Homestake Mining Company of California

**RE: Homestake Mining Company of California – Grants Reclamation Project –
Response to NRC’s Staff Acceptance Review of the HMC Request for Amendment
to License SUA-1471 for Alternate Concentration Limits**

Attachment 1. Response to NRC comments in May 17, 2023 letter of nonacceptance of the ACL Application for technical review

Attachment 4. HMC Response to NRC Staff Talking Points from June 15, 2023 Public Meeting	
Comment	HMC Response to Comment
1-1	<p>The LAR does not provide information regarding the transfer of property and structures within the proposed control boundary including:</p> <p>The long-term disposition of infrastructure within the proposed boundary is a subject to be addressed at license termination and does not relate to the completeness of the LAR for detailed technical review. Nonetheless, HMC is providing below as much information as is reasonably practicable at this time to address the NRC staff's comments here.</p> <p>Respectfully, in HMC's opinion, none of the items in Comments 1-1 and 1-(a) through -(h) concerning property and structures within the proposed control area boundary are required by NRC regulation, or s

EXHIBIT D

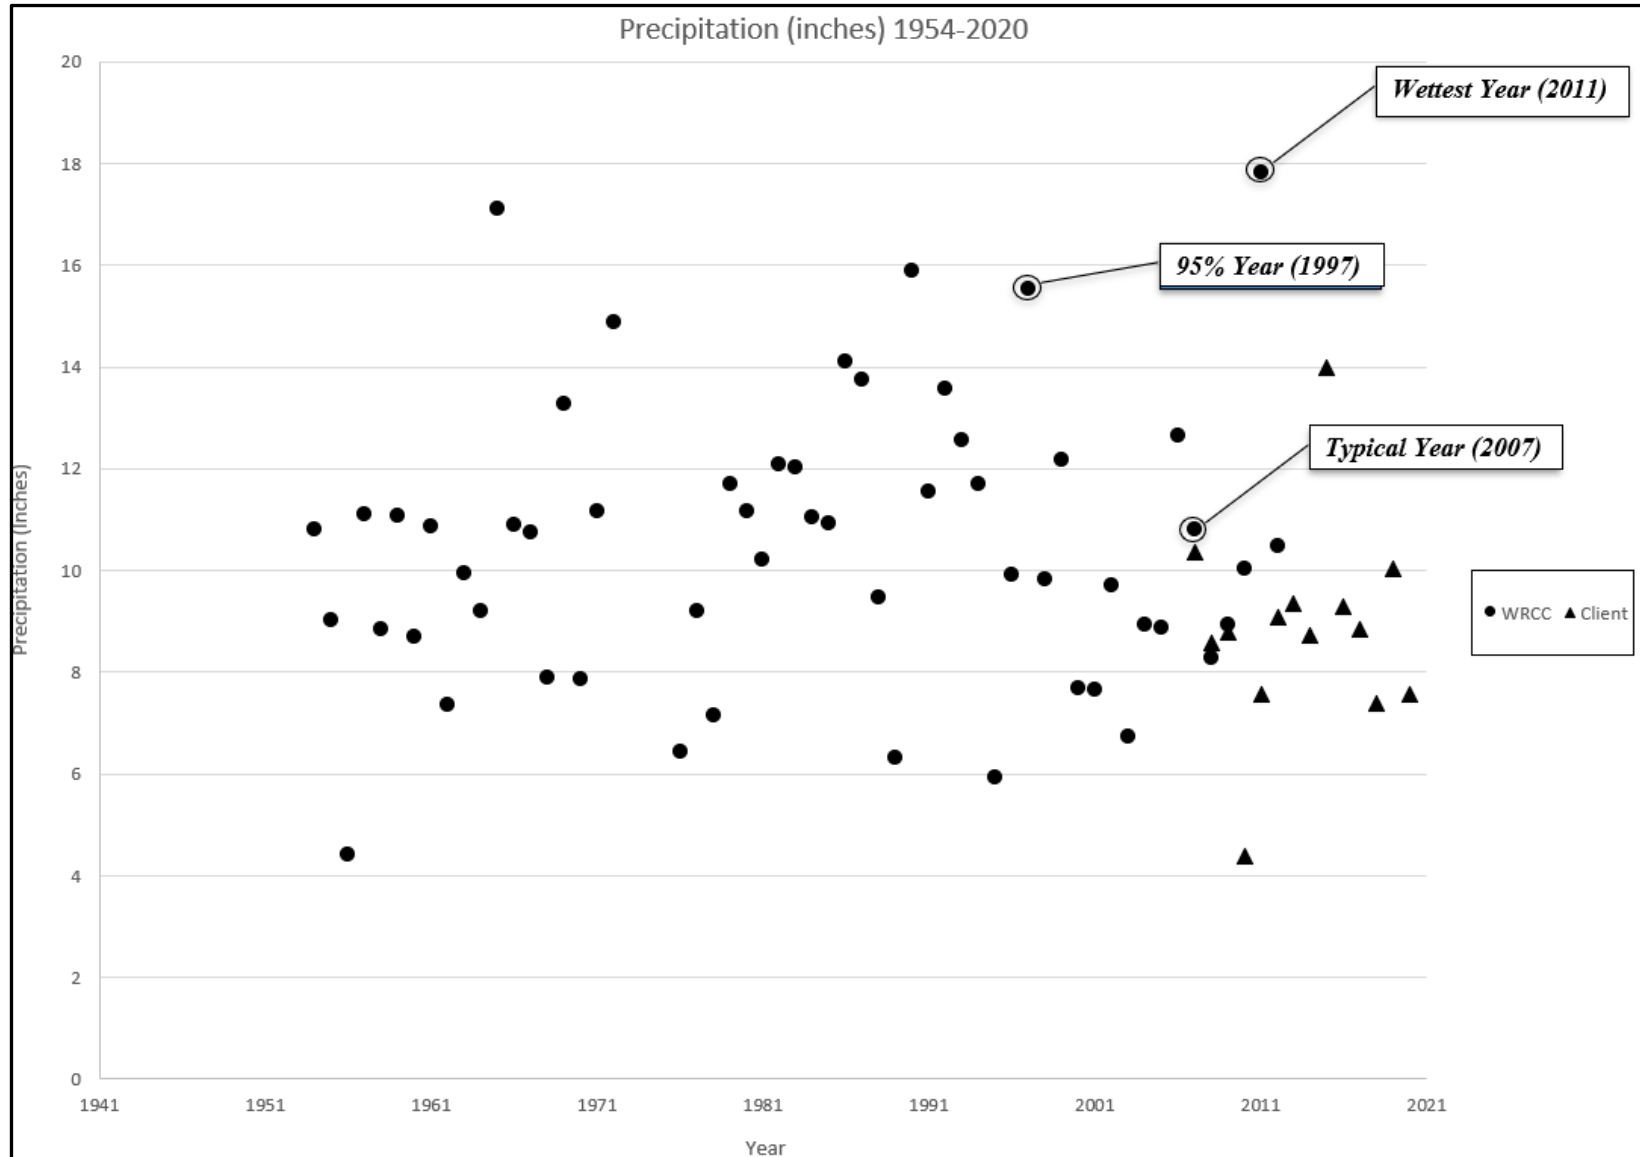
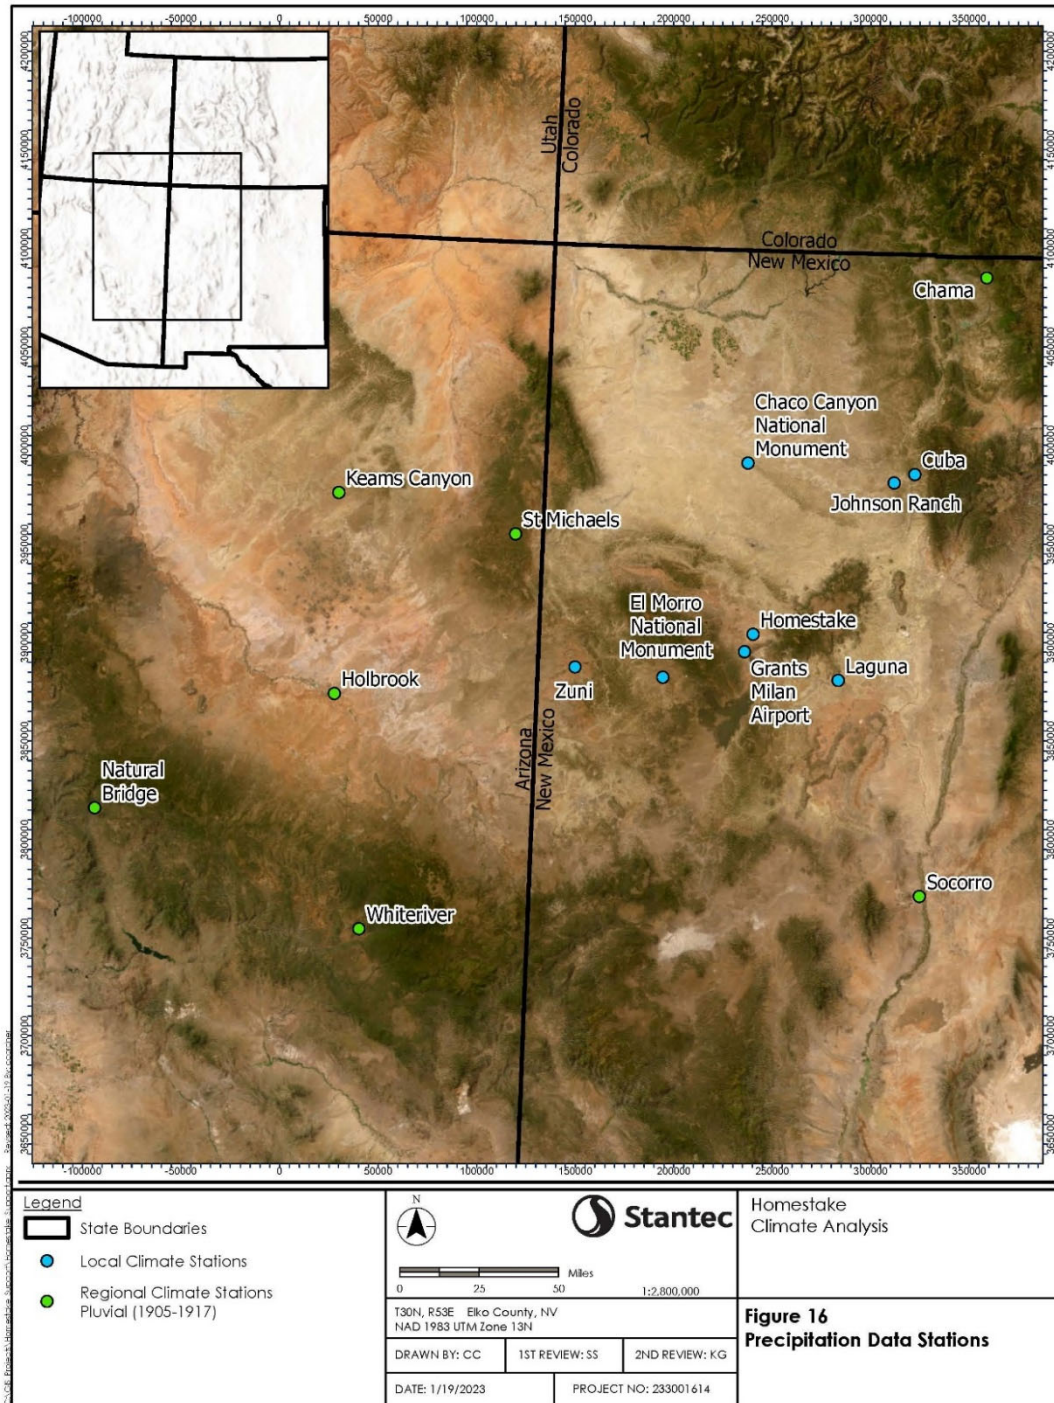
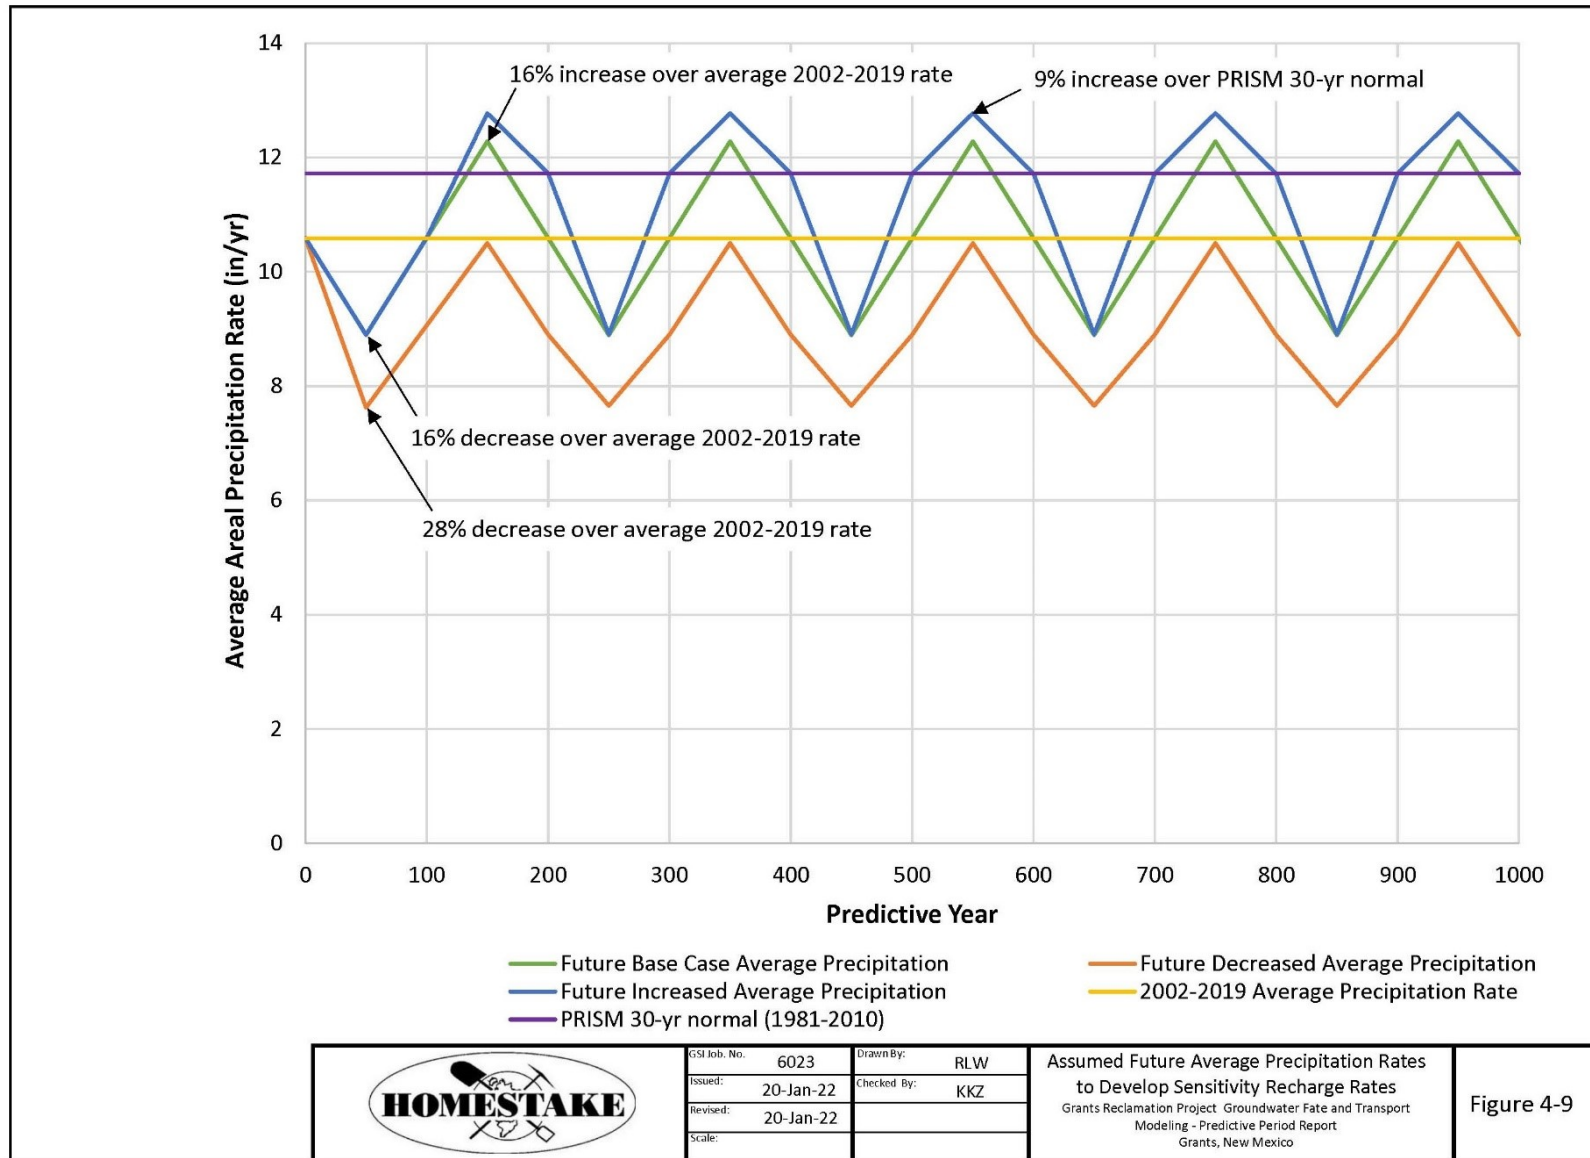
1-3 Discussion-C	The NRC staff is concerned that HMC selected a <u>range of precipitation rates</u> for the base case and bounding case conditions that <u>was generally less than the recent precipitation rates from 1986 to 2022</u> . Because of the uncertainty in climate projections, the level of support required for the assumption that future precipitation rates will be below the historical average for very long	<p>Please see detailed response to Comment 1-3 Discussion-B for additional information on the inapplicability of NRC's cited data for comparison. As noted in that response, the range of precipitation rates for the base-case are <u>the same as or greater than the recent precipitation rates</u> from 1986 to 2022.</p> <p>Nonetheless, we appreciate the NRC bringing to our attention that Table 1.2-5 of the ACL application contains an error that is HMC's fault. Based on further review, Table 1.2-5 inadvertently provided data that is not representative of the Grants-Milan airport meteorological station</p>

GSI Job. No.	6023	Drawn By:	RLW	Total Applied Base Case and Sensitivity Volumetric Recharge Rates Grants Reclamation Project Groundwater Fate and Transport Modeling - Predictive Period Report Grants, New Mexico	Figure 4-10
	Issued:	20-Jan-22	Checked By:	KKZ		
	Revised:	20-Jan-22				
	Scale:

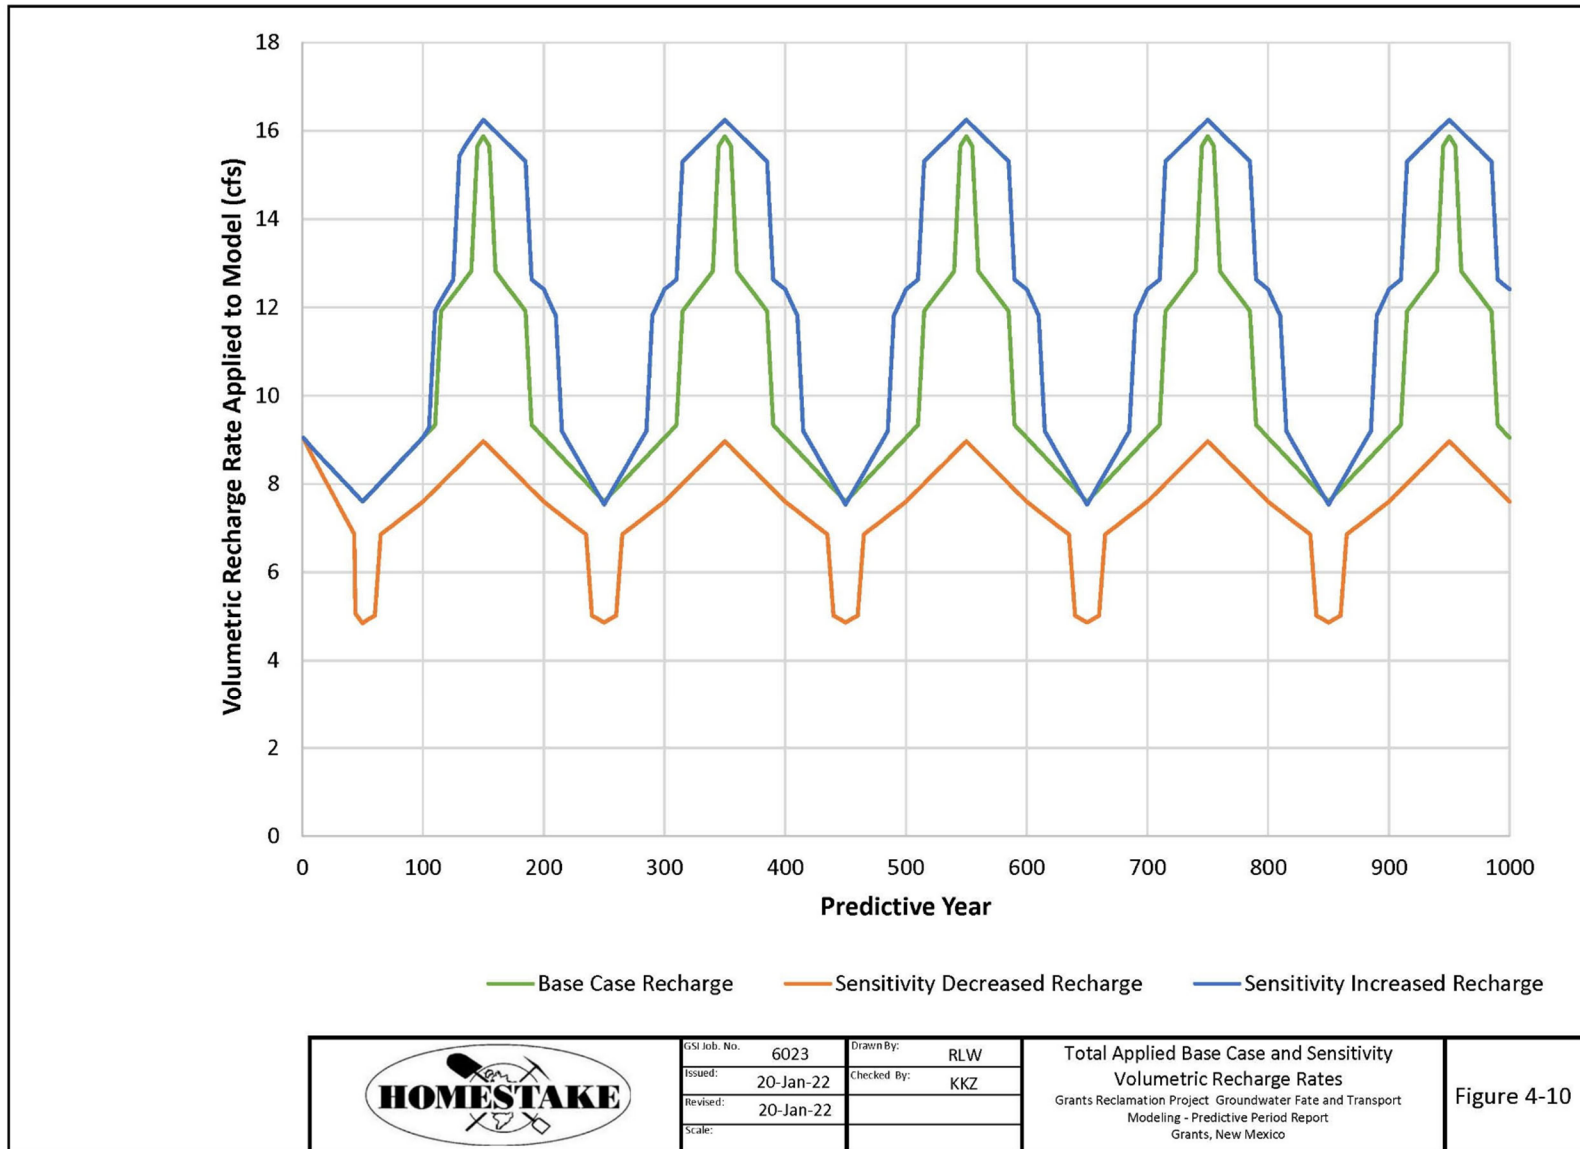
1-5	<p>The assumed recharge rate in the groundwater model for years with above-average precipitation is not well supported in the LAR.</p>	<p>As stated previously, HMC believes that the NRC request for additional information on recharge rates is not a sufficient basis in regulation or guidance for declining to accept the ACL LAR for detailed technical review.</p> <p>Please see detailed response below for further discussion.</p>

Attachment 4. HMC Response to NRC Staff Talking Points from June 15, 2023 Public Meeting		
Comment	HMC Response to Comment	
1-5 Discussion	<p>As discussed in Comment 1-3, the assumed precipitation and recharge rates are risk significant because of the potential for modeled drying of the cells representing the alluvial aquifer.</p> <p>In Section 1.2.2.3.3 of the ACL application, HMC discussed that the annual precipitation in 2020 was 7.55 inches and the average pan evaporation is approximately 63 inches/year, resulting in an annual moisture deficit for the region. Further, in Section 4.4 of the Groundwater Flow and Transport Modeling – Predictive Period Report, HMC discussed that projected increases in temperatures will significantly reduce groundwater recharge. The NRC staff note that recharge can still occur in areas where pan evaporation rates exceed precipitation rates because of temporal variability and averaging. The pan evaporation is an annual average. However, precipitation is episodic and not temporally distributed evenly throughout the year, so precipitation events can exceed average evaporation rates. During these events, precipitation can result in recharge before evapotranspiration can remove all of the moisture, especially during short, intense rainfall events. Also, the evaporation rate can vary significantly throughout the year. Accordingly, precipitation in colder periods could exceed evaporation rates, which can include snow melt. Lastly, higher temperatures can result in more evaporation, but the likelihood and magnitude of significant precipitation events also increases with the increased energy and increased air moisture holding capacity associated with those higher temperatures, as discussed in Section 10 of NUREG/KM-0015.</p>	<p>Ongoing trends in climatic conditions show a clear increase in drought from which we can infer a commensurate decrease in recharge in the basin over the last 25 years. This trend is expected to continue and accelerate into the future as stated by the NMBGMR in their recent climatic report for the state of New Mexico (NMBGMR; Dunbar et al., 2022). HMC is not aware of any reliable data that would refute this trend or indicate that the basin will either experience higher future recharge based on historical averages or that trends will reverse and recharge will increase relative to historical averages in the basin.</p>

EXHIBIT E

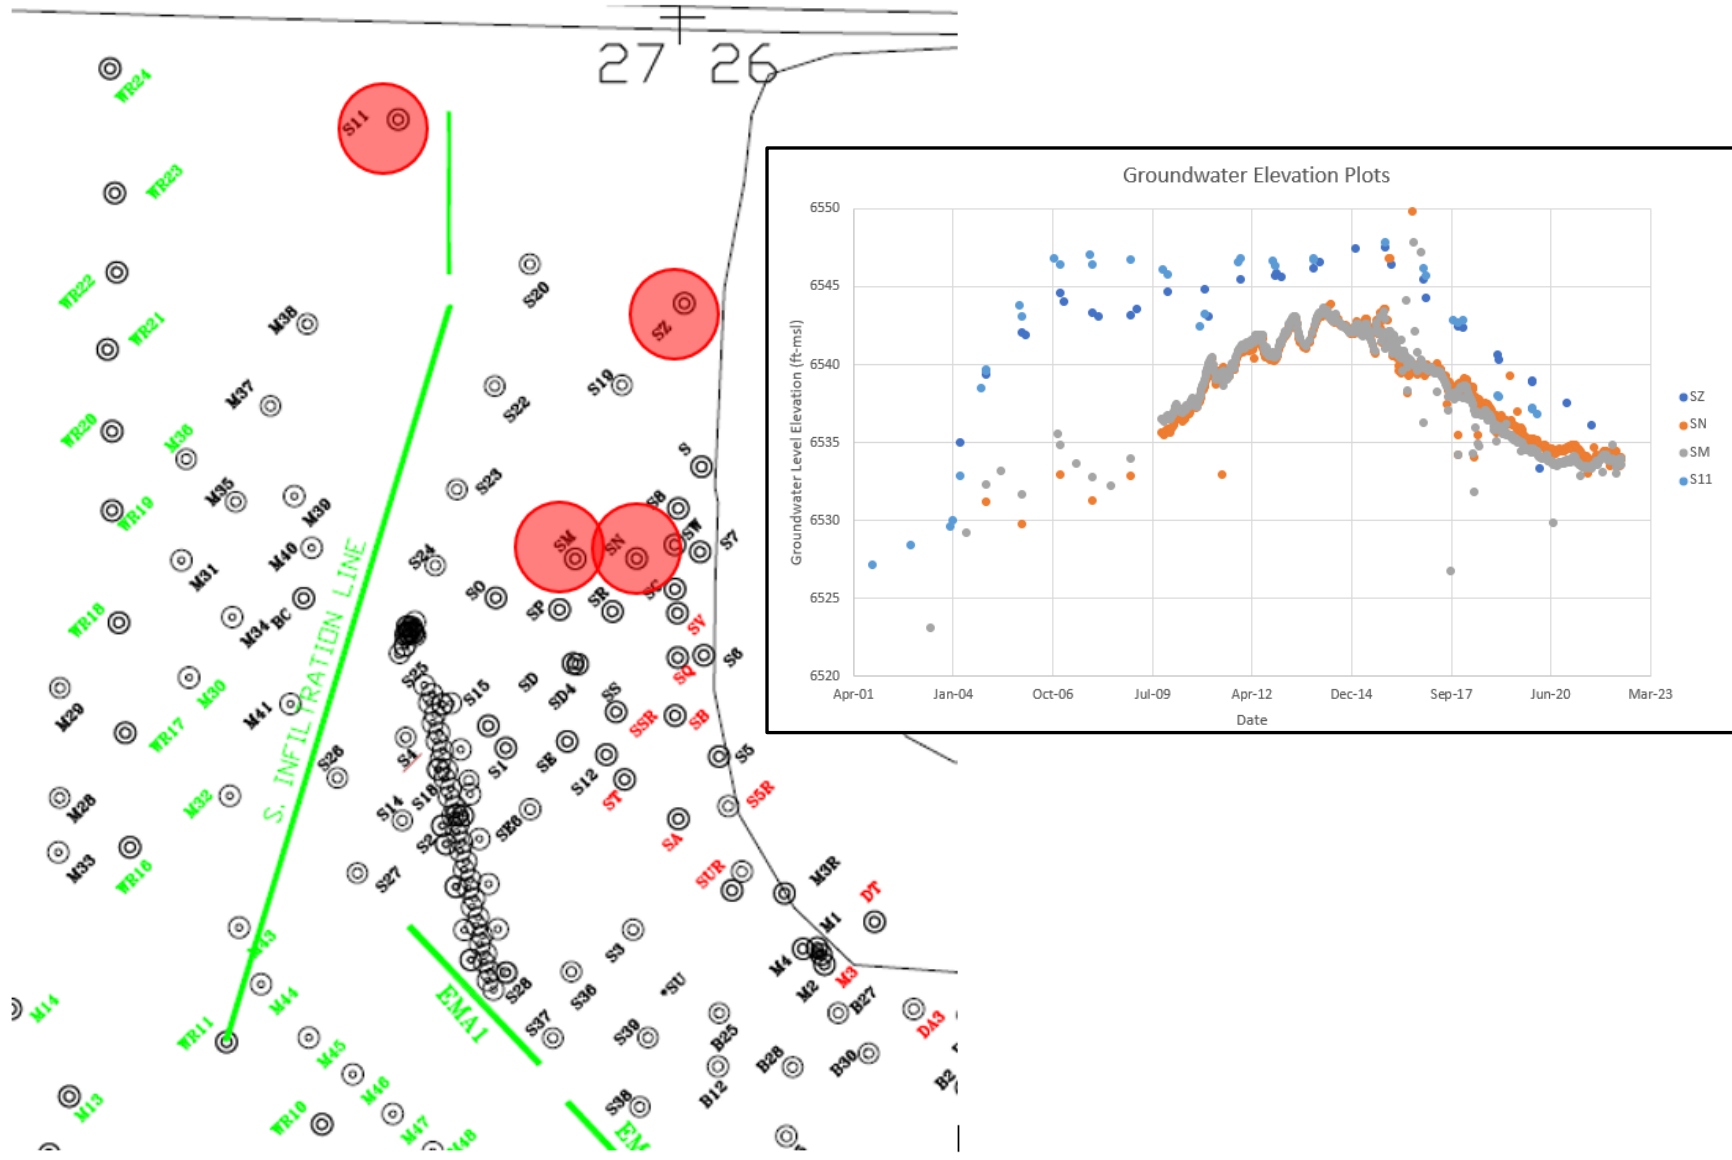
3-2 Discussion j	<p>Fifth, a constituent concentration based on the current observed maximum levels at well SZ is not likely representative of groundwater flow through the alluvial aquifer at the proposed POC. Historically, the concentrations of all constituents at well SZ have been elevated and more consistent with the 1980’s tailings liquid quality rather than that of the alluvial aquifer. The NRC staff assumes this concentration is a relict when tailings fluid spilled into the aquifer and, at this location, the strata had a high affinity to sorb the constituents. If correct, such strata would not yield sufficient flux to the aquifer to significantly contribute to the plume quality downgradient of the POC. <u>The applicant has not provided a boring log for this well or other tests to better define its role as a POC well.</u> It should be noted that a conclusion similar to staff’s assumption that well SZ is not representative of the aquifer was reached by the licensee in evaluating water levels during aquifer testing/monitoring. [emphasis added]</p>	<p>See response to Comment 3-2e, above.</p> <p>The boring log from Well SZ is provided in Exhibit E. As shown in the drilling log, the screened interval is within the saturated alluvial material. In contrast to NRC’s speculation, the drilling log indicates the well had an estimated yield of 15 gpm, which is well within the observed ranges of well yields in the vicinity of the site. The staff is correct that an HMC report in the early 1980s indicated that the water level in the well may have not been representative of groundwater in the early 1980s after less than a decade of data (the well was drilled in 1977). However, the last two decades of monitoring demonstrate the well acts consistently with other wells in the general vicinity as shown by the areal map and hydrograph included in Exhibit E with the boring log.</p> <p>See response to Comment 3-2e, above.</p>
